# 1963 - 1967 Corvette: Service Bulletin: Fuel Gauge System Diagnosis

**Subject:** Fuel Gauge System Diagnosis

**Bulletin Number:** DR #752, Section VIII

**Date:** July 19, 1965

FIGURE ONE

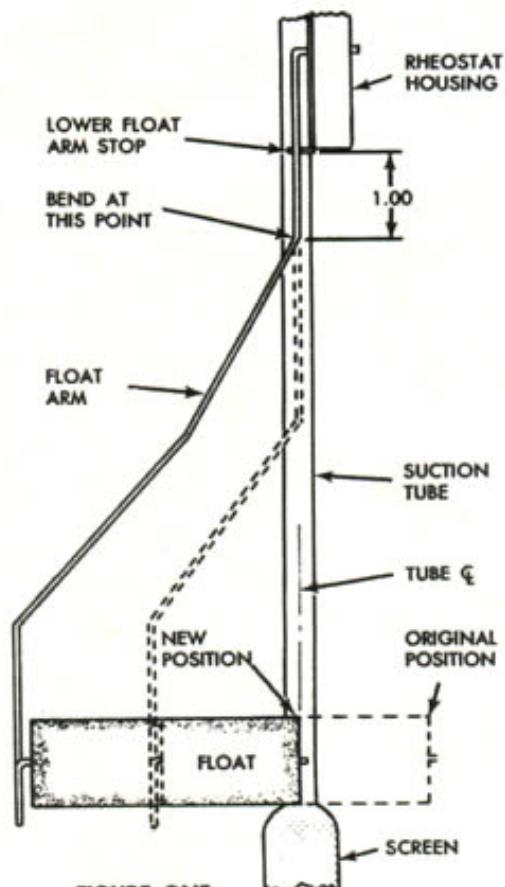
**CAUTION:** In the above procedure, there is a possibility of breaking the solder joint where the suction tube passes through the mounting plate. If this occurs, or if a new tank sending unit is installed on tanks without the orange paint identification, the replacement sending unit should be reworked per Figure 1 (Page 6) prior to installation.

FIGURE TWO

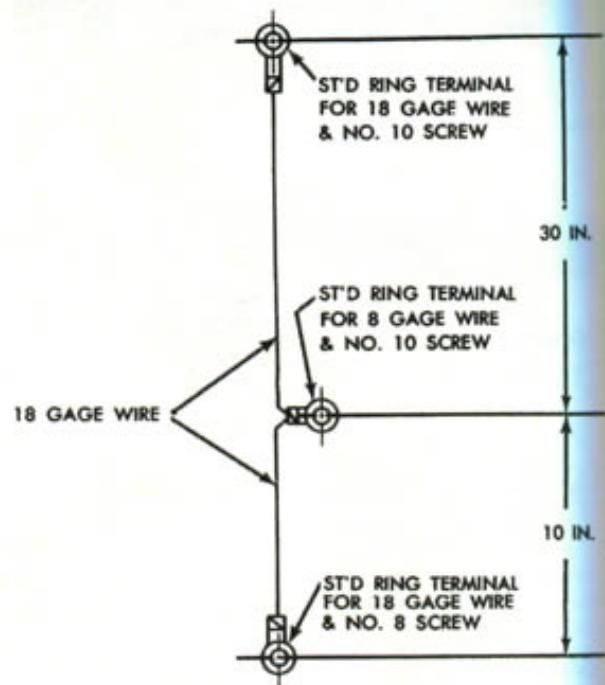
If ground circuit correction is needed, make a ground wire assembly as shown in Figure 2, Page 6. Install as shown in Figure 3, Page 6.
